Service information

Reference no.: SDA_93398

Detachment of the magnet in the carafe of milk in Xelsis line .

Image 1

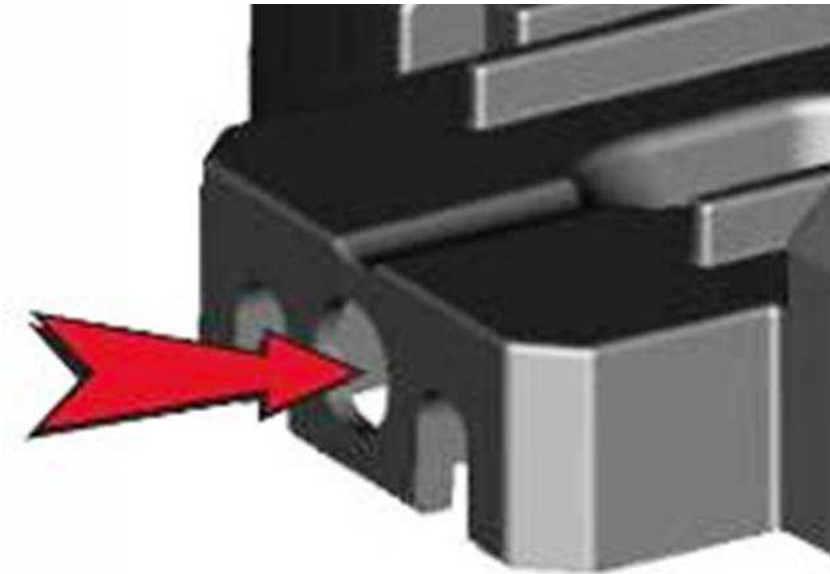
INFO:
The zone of magnet part in the plastic component is to tight and could be damaged and break during the usage (image1).

CURE:
The magnet zone on the plastic component has been modified to remove any tight due to the presence of the magnet component inside the plastic support; the modified plastic part can be recognize by the circle sign on it as shown in the image 2. The code 11012816 remains unchanged.
